**ADDENDUM NO. 2**

To the Contract Provisions for  
CITY OF ARLINGTON, WASHINGTON

Airport Blvd Phase 1A

**PROJECT NO P02.342**

REFERENCE SHEET NO. WP 3 OF SHEETS

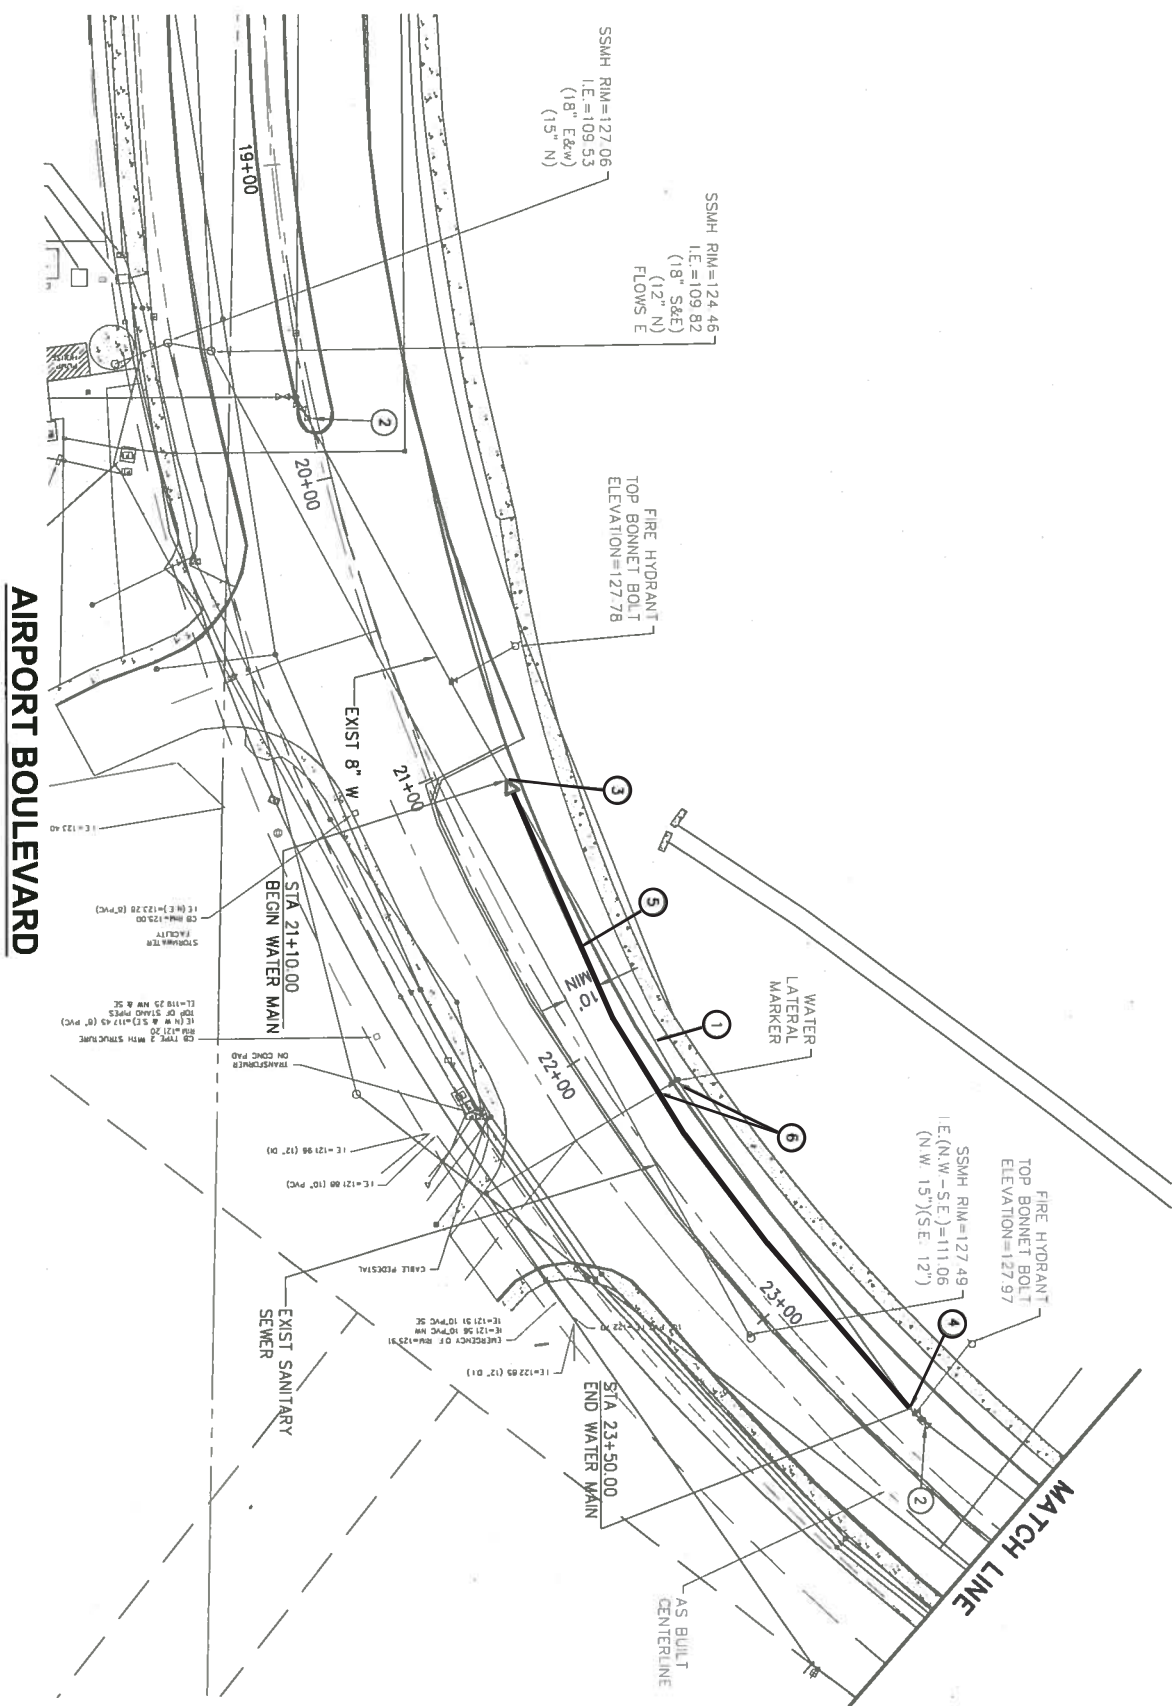
Sheet WP3

Revise Construction Note 3 to:

“Install 12x10 reducer and connect to 12” water main to existing 10” water main.”
